## Application for Waiver from Construction Standards for Public Water Systems

Water System Name	Ambar Estate	PWS ID	<u>95750</u>
Project or Facility	Well #1 (L142249)	County	<u>Yamhill</u>
Need for waiver identified:  Water System Survey		Date of Survey	
	$\square$ Plan Review # $154-2024$

Construction standard requested to be waived: <u>OAR 333-061-0050 (2)(a)(D) & (E) regarding 100-ft setback from roadway and parking lot.</u>

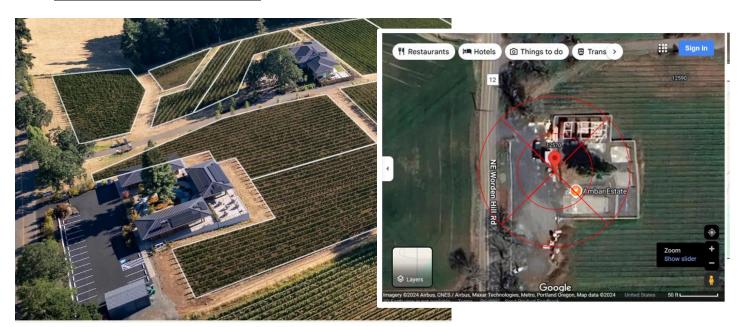
As shown in the map below, within the 50- and 100-ft radii around the wellhead are NE Worden Hill Rd, which is is a public roadway within 100-ft of the well (L142249) and a parking lot owned by Ambar Estate, which is less than 50-ft away from the wellhead. No other hazards are within 100-ft of the wellhead.

## Waiver ID 507-2024 Entered into waiver database Plan Review Coordinator's notes: 0050(2)(a)(D) is allowed under rule, so this waiver form is being evaluated only for 0050(2)(a)E. Well is properly constructed in a confined aquifer with low susceptibility. After due consideration the above requested waiver from the construction standards of OAR 333-061-0050 is hereby: Approved Comments: □ Denied □ Denied □ Denied □ Denied □ Denied □ Date □ Date
